Work Order ID 149509

Item Name: Quick Release Basket and Long Cargo Tube Mounting Provisions, Fits LH or RH

DART SERVICE INSTRUCTION

TO AMEND INSTALLATION INSTRUCTIONS D350-607-3 Rev.D,
INSTALLATION INSTRUCTIONS D350-607-4 Rev. C AND
INSTRUCTIONS FOR CONTINUED AIRWORTHINESS ICA-D350-607 REV. 6
REF TCCA STC: SH94-14
REF FAA STC: SR00213NY
REF EASA STC: EASA.10016996
REF BRAZILIAN STC: 2007S03-03/-04/-05/-06

FIGURE 1: INSTALLATION OF D4775-041 FWD STRUT

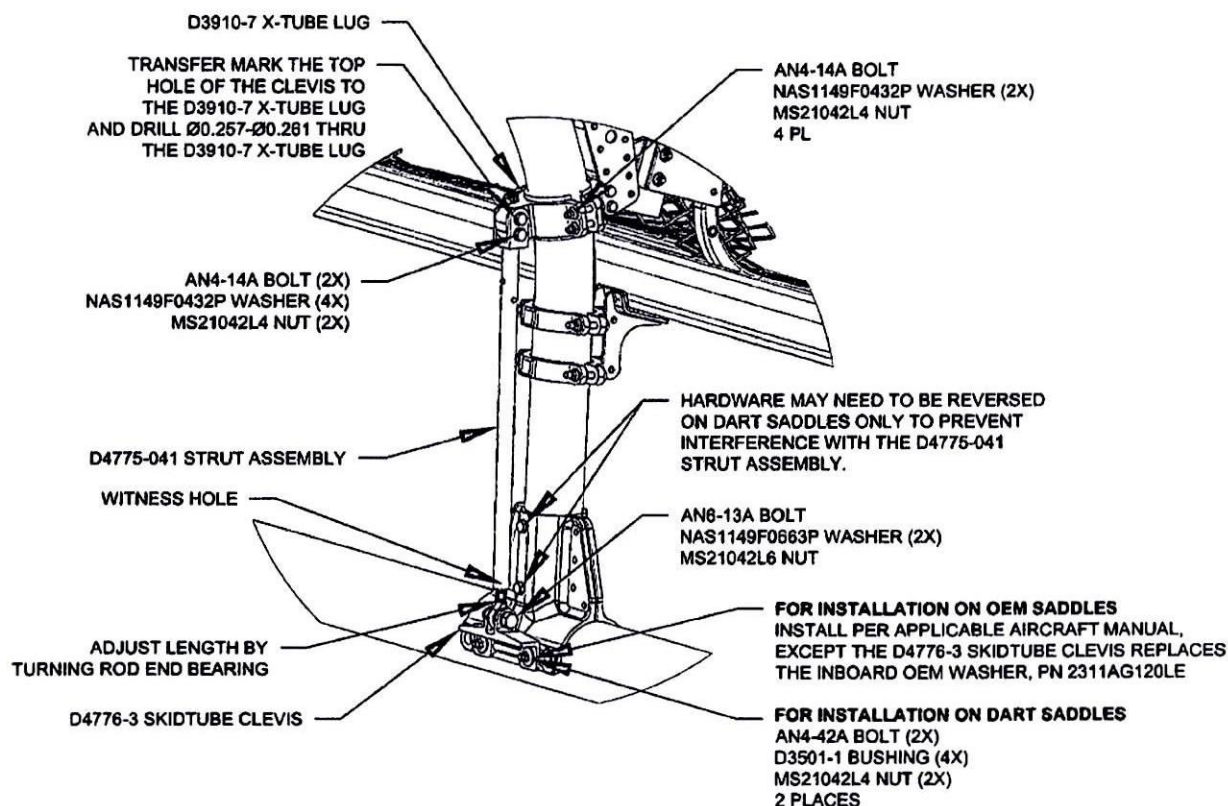
Install the D350-607-501 Conversion Kit, D350-607-511 Quick Release Mounting Kit or D350-607-431 Strut retrofit kit per Installation Instructions D350-607-3 Rev. D or D350-607-4 Rev. C. While installing the Forward Strut perform the following:

- 3.1 Substitute the Forward Lower D3910-5 X-Tube Lug with the D3910-7 X-Tube Lug as shown in Figure 1.
- 3.2 Install the forward D4775-041 Strut Assembly. Transfer mark from the upper hole on the clevis of the D4775-041 Strut Assembly to the D3910-7 X-tube Lug and drill thru the lug $\varnothing 0.257$ - $\varnothing 0.261$ as shown in Figure 1. Touch up chemical conversion coating per MIL-DTL-5541. Check the witness holes located at the bottom end of the D4775-041 Strut Assemblies to ensure that the thread from the rod end extends past the witness hole.
Torque MS21042L4/-4 nuts to 50-70 in-lbs (5.7-7.9 N-m). Torque MS21042L6/-6 nuts to 160-190 in-lbs (18.1-21.5 N-m).
- 3.3 Complete the installation in accordance with Installation Instructions D350-607-3 Rev. D or D350-607-4 Rev. C.
